NSW Independent  
Planning  
Commission

Pitt Street South  
OSD

INTERNAL AMENITY  
SUBMISSION

18 March 2021  
Final

C. Projections beyond the building envelope

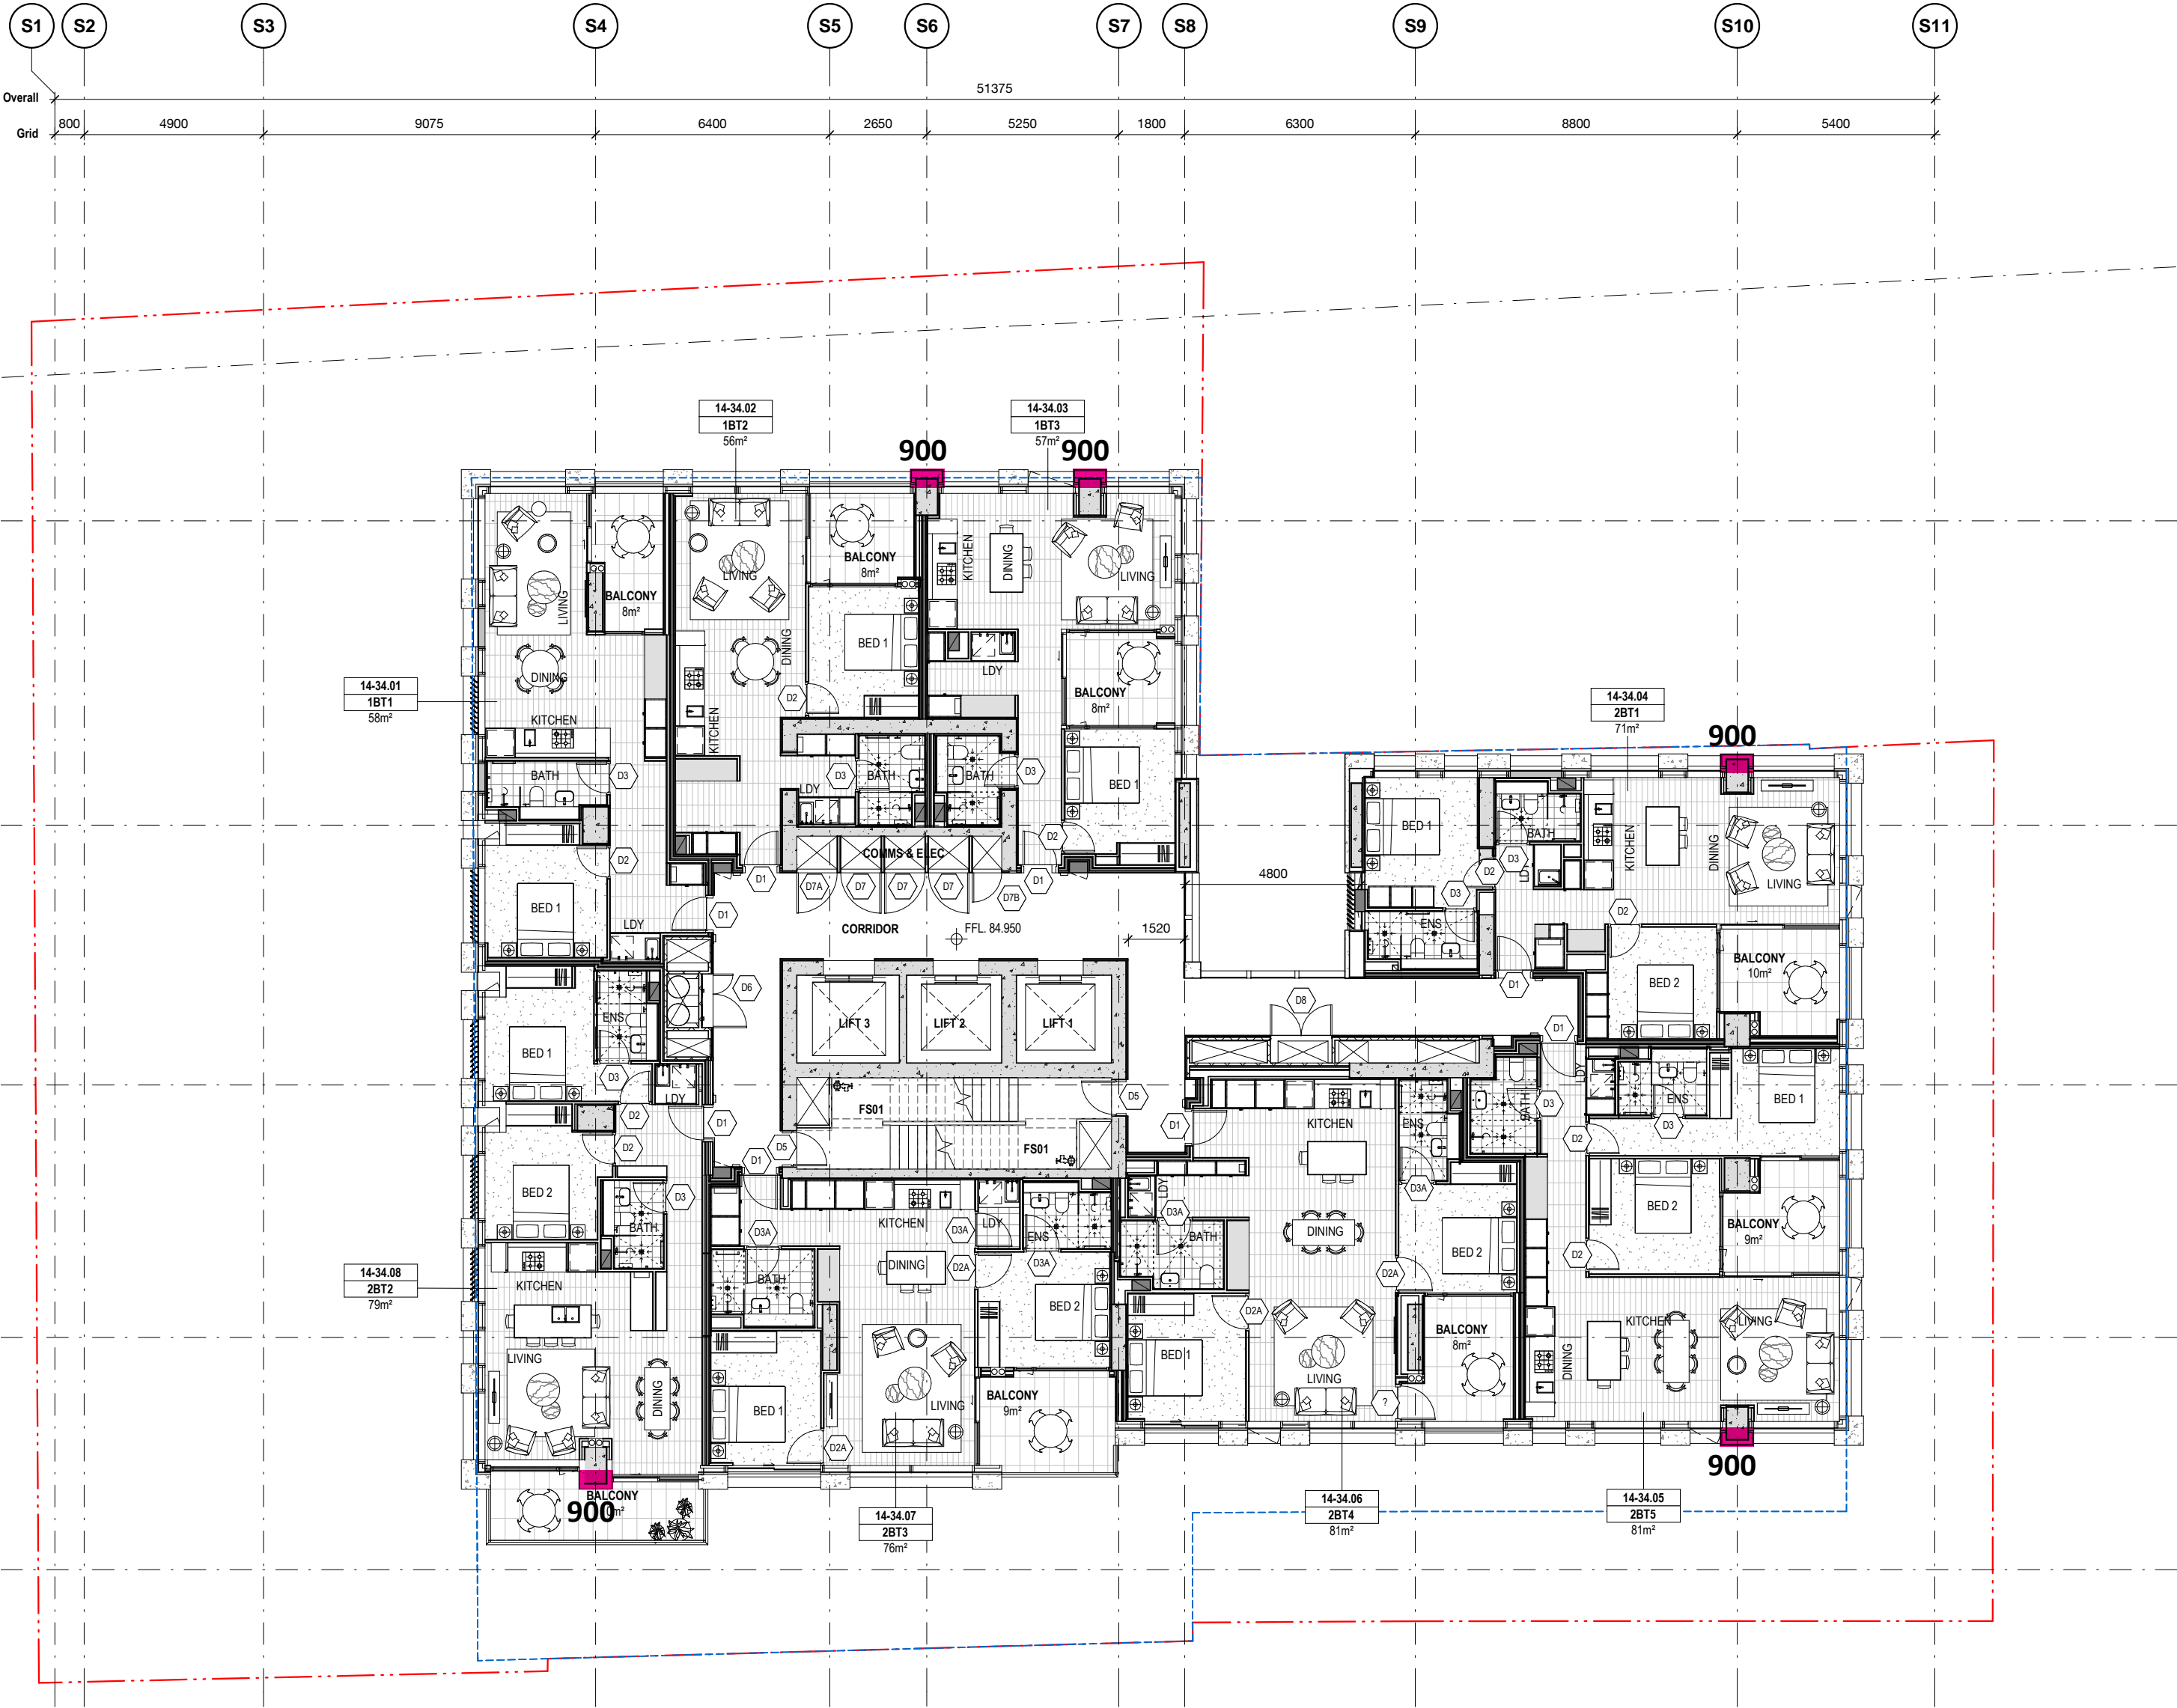
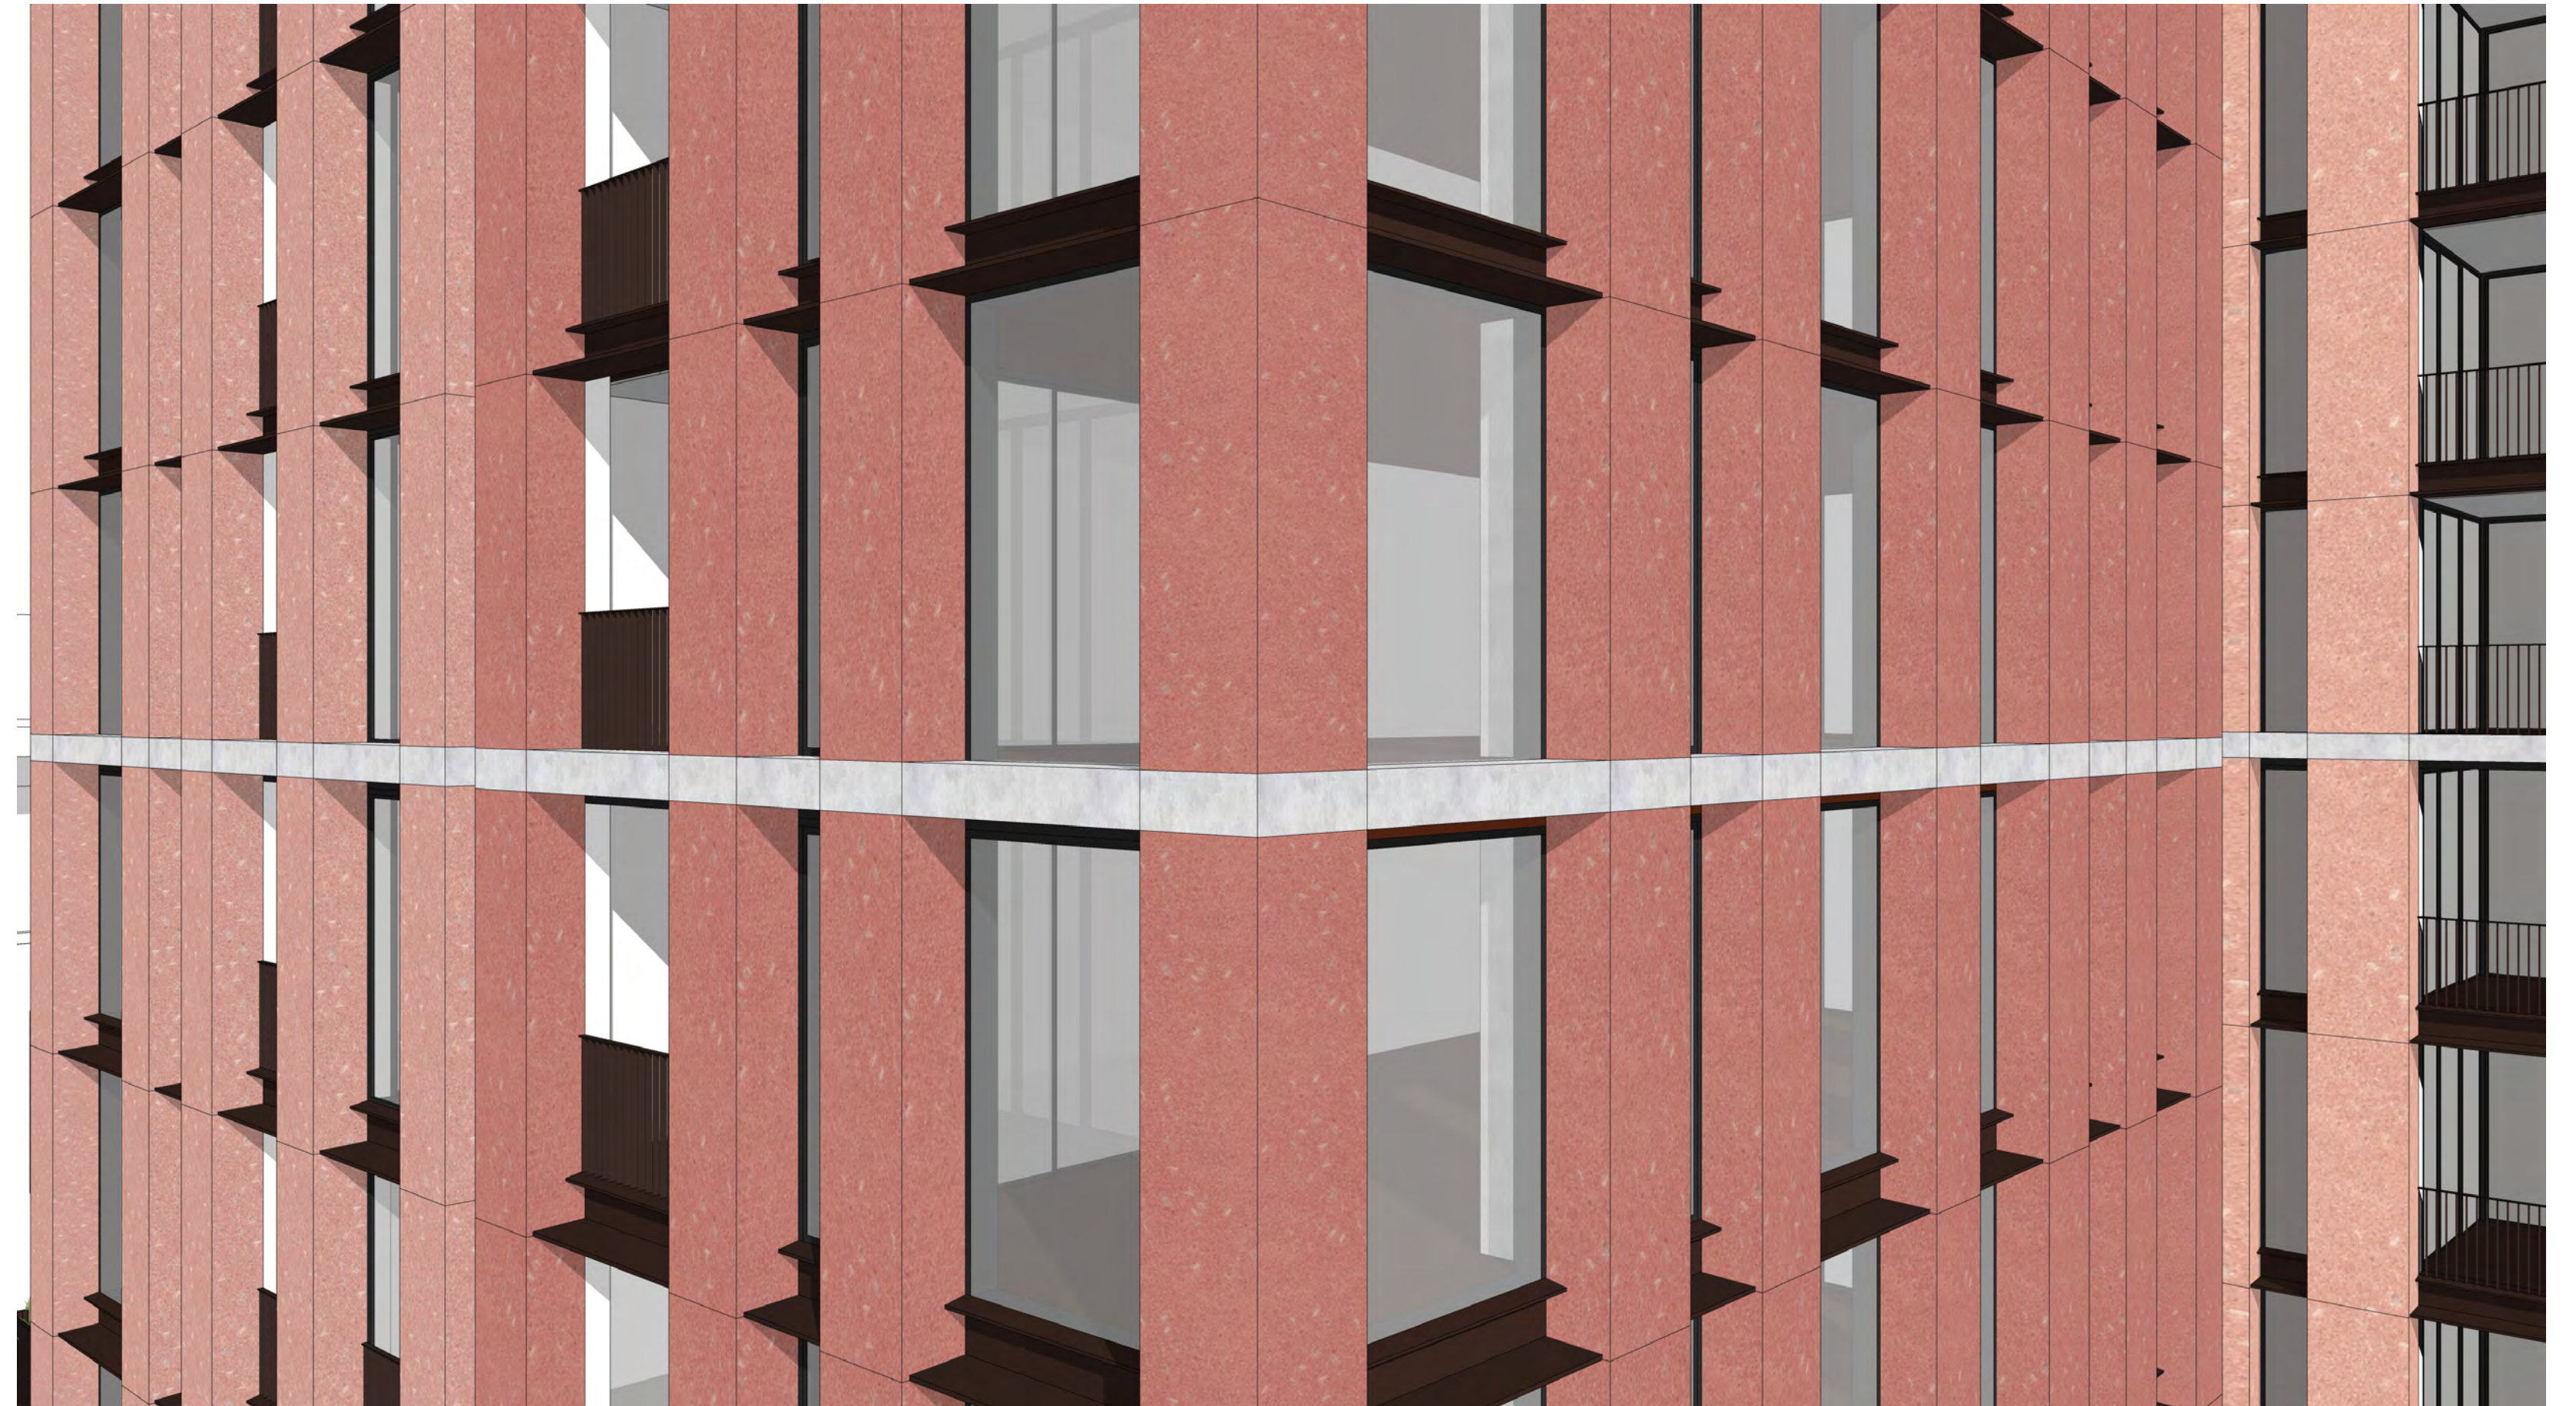
- The majority of these change were rejected by the Panel, “The Panel reasserts its earlier assessment that the minor encroachments outside the building envelope create no adverse impacts on privacy and solar access. Whilst the Panel applauds the project teams’ efforts to reduce these encroachments, the Panel believes the reduced depth to the GRC facade elements diminishes the architectural quality of the facade, and should be calibrated to the building orientation (e.g. maintaining the deeper panels on east/west)”

*Review the appropriateness of the proposed projections beyond the approved building envelope with respect to any additional impacts when compared to a complying development, including further consideration of any:*

- \* overshadowing impacts to adjoining residential properties*
- \* privacy and visual impacts resulting from further encroachments on minimum building separations*
- \* streetscape impacts*
- \* ongoing maintenance of boundary conditions.*

- DD on GRC from 450 x 800/900 to 250x 900*
- Reduce depth to comply with town planning envelope*
- Improved consistency of width (800 v's 900)*
- Increased solar access to living rooms*
- Refined locations to create regularised proportions relating to internal rooms*

- 450mmD x 800mmW GRC

- 250mmD x 800mmW GRC
- 200mm reduction in depth

- 450mmD x 800mmW GRC

- 250mmD x 800mmW GRC
- 200mm reduction in depth
